ITEM: 6.12	REPORT SUMMARY MINOR VARIANCE APPLICATION FILE NUMBER A073/23
-------------------	--

**MINOR VARIANCE APPLICATION
FILE NUMBER A073/23**

CITY WARD #:	2
APPLICANT:	Sonja Placido
AGENT:	Contempo Studio (Marin Zabzuni)
PROPERTY:	38 Davidson Drive, Woodbridge
ZONING DESIGNATION:	See below.
VAUGHAN OFFICIAL PLAN (2010) DESIGNATION:	Vaughan Official Plan 2010 ('VOP 2010'): "Low-Rise Residential" by Volume 2, Section 11.11 – Woodbridge Centre Secondary Plan.
RELATED DEVELOPMENT APPLICATIONS:	None
PROPOSAL:	Relief from the Zoning By-law is being requested to permit a proposed cabana, swimming pool and retaining wall. Relief is also being requested to permit two (2) driveways (located in the front and exterior side yard) and increased maximum driveway width.

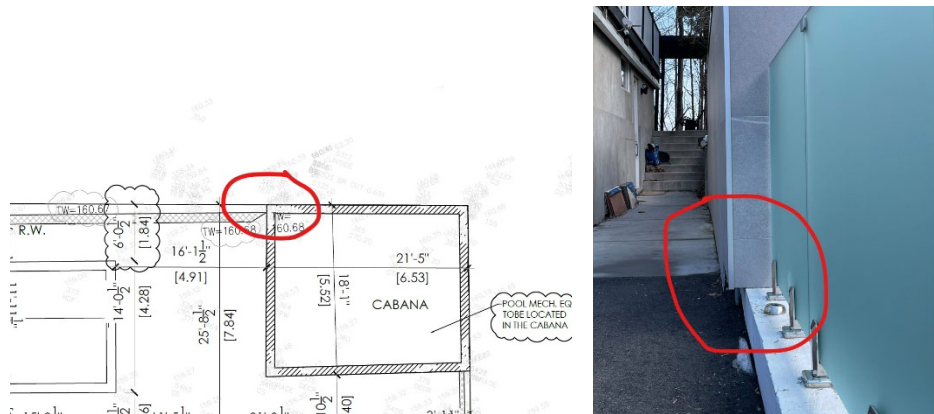
Development Planning staff has now completed our comprehensive review of this application since my site visit. We do still have concerns with both the cabana and the pool and are challenged to support these variances as is. The 0 meter setbacks on both sides of the cabana and the proximity of the pool to the street results in adverse massing impacts and increased activity near the shared lot lines. We are recommend the removal of the cabana. Since it may be difficult to remove the cabana without impact to the pool, we are also recommended the relocation the pool so it located entirely behind the existing dwelling.

Please note that even if the Cabana and Pool were removed entirely there are still additional variances that would need to be reviewed through this Committee of Adjustment application (for the driveway, etc.).

Please kindly note that if the home-owner wishes to proceed as is (with the existing Cabana and Pool), Development Planning Staff will not be in a position to support or recommend approval for the application.

The whole purpose of our application is to maintain the Cabana and pool. If we removed those, we would not require a committee of adjustment hearing.

The homeowner bought the property as is and would like to maintain these structures. Please advise on next steps. Thank you for your consideration in this matter.

SITE PLAN

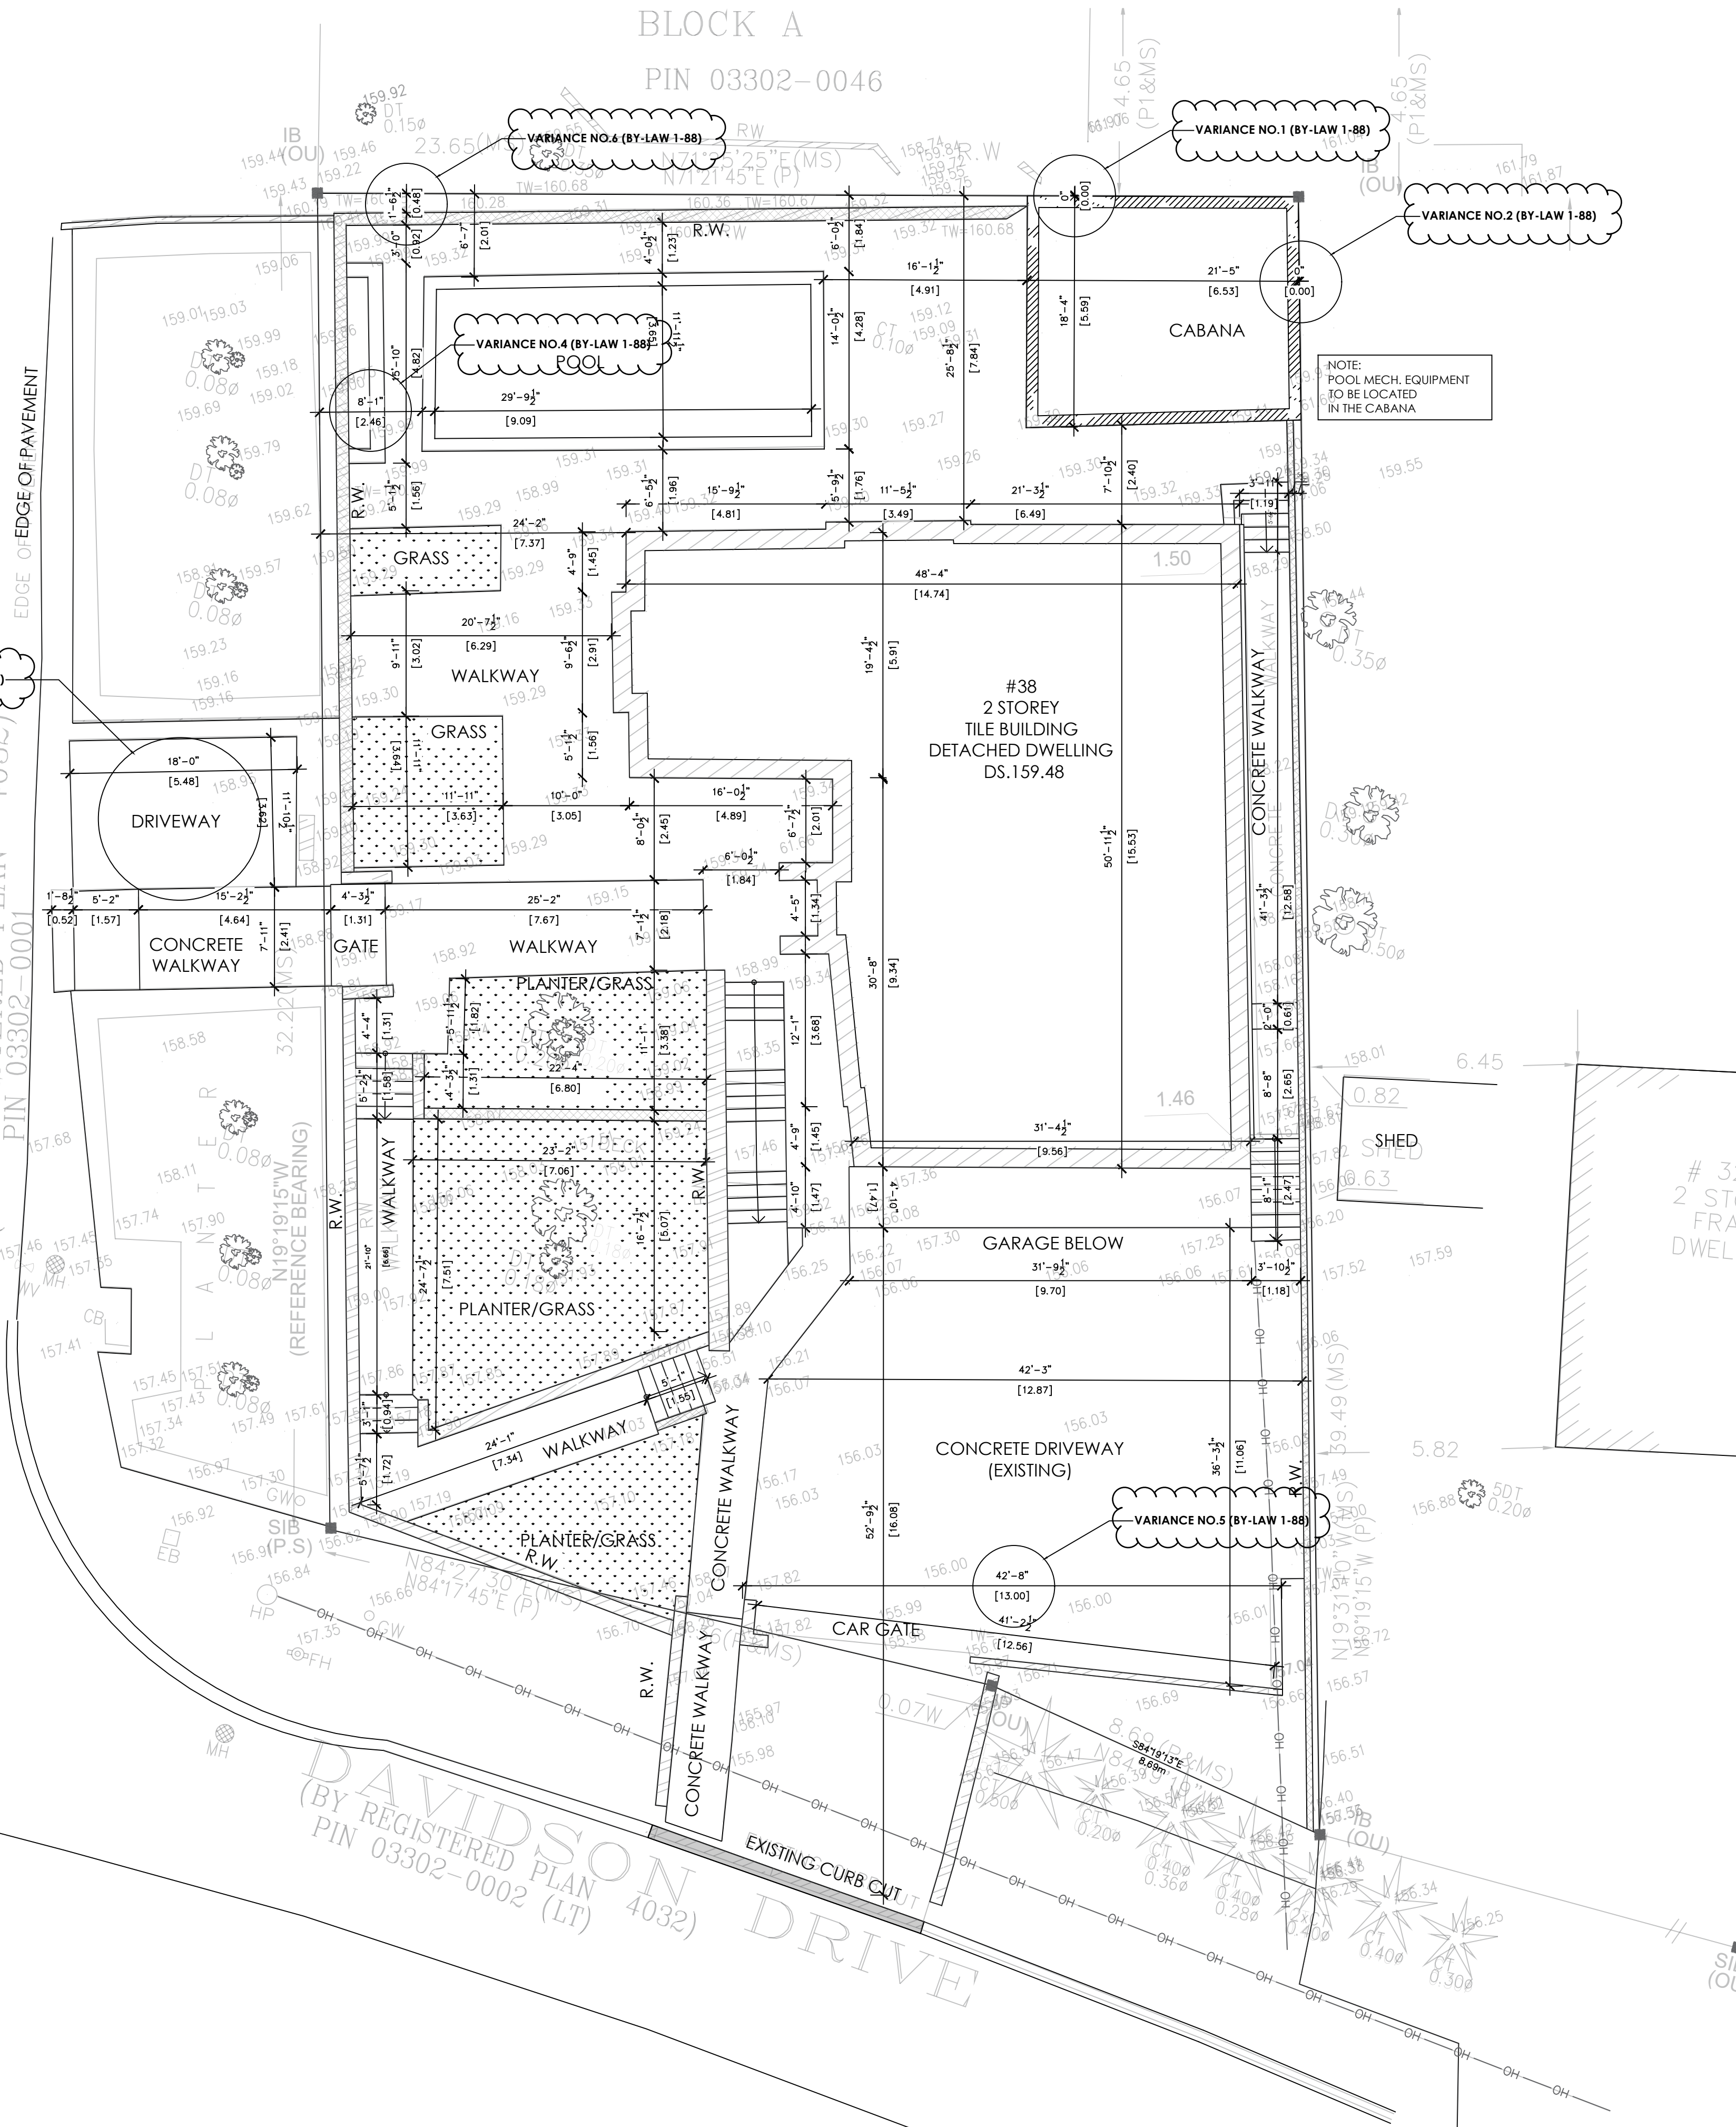
- Referring to the markup below, staff is concerned that the cabana exceeds the property line and is built on neighbouring property. Please further clarify the site plan drawing with the survey map, and create an overlay drawing to demonstrate there is no encroachment to the neighbouring property.

- Further to the above, staff is concerned about the existing cabana being too close to the neighbouring property. Particularly with the retaining wall, the impact on the neighbours is significant and can not be mitigated. Considering the Cabana is an as-built structure, staff could not support this application.

The cabana, constructed with a zero-meter setback from the north and east property lines by the previous owner, manages roof rainwater runoff through a downspout located at its southeast corner, preventing runoff from affecting neighbouring properties to the north and east.

Site inspections confirm that there are no downspouts directed towards adjacent properties, and the cabana does not cause flooding or other negative impacts. Similarly, the retaining wall, also built with a zero-meter setback from the north property line, has been assessed during site visits and found to have no adverse effects on the neighbouring property.

The Development Planning Department ('Development Planning') does not support Variances 1 and 2 for the 0.0 m rear and interior side yard setbacks for the accessory structure (Cabana). The structure has a flat roof design and is fully enclosed. The Subject Lands are a corner lot which abuts 15 Waymar Heights Boulevard to the north and 32 Davidson Drive to the east. The north wall of the Cabana faces the front and interior side yard of 15 Waymar Heights Boulevard, and the east wall of the Cabana faces the rear yard of 32 Davidson Drive.

One intent of an interior side and rear yard setback is to provide space for maintenance access to any structures near a lot line to avoid trespass onto abutting lands. As the proposed interior side and rear setbacks are 0.0 m, the Cabana wall is abutting two lot lines. Wall vents on the Cabana's east wall were also observed. In its current position,

permission from the abutting landowner(s) is/are required to maintain the Cabana north and east walls and vents on the east Cabana wall. Another intent of the setback is to provide spatial separation to facilitate plantings and/or the installation of a privacy fence to further buffer residential yards from one another, which is impaired with the current placement of the Cabana. Additionally, adverse massing impacts were observed as a result of the 0.0 m setback on the two abutting properties, and in particular the dwelling located on 15 Waymar Heights Road, which is in proximity to the mutual lot line where the cabana is located.

Therefore, for Variances 1 and 2, it is Development Planning's opinion that permitting a structure of this scale where a 0.0 m setback to the interior side and rear lot lines exist, is a substantial deviation from the zoning by-law's intent, is not minor in nature, nor desirable and appropriate for the use of the land.
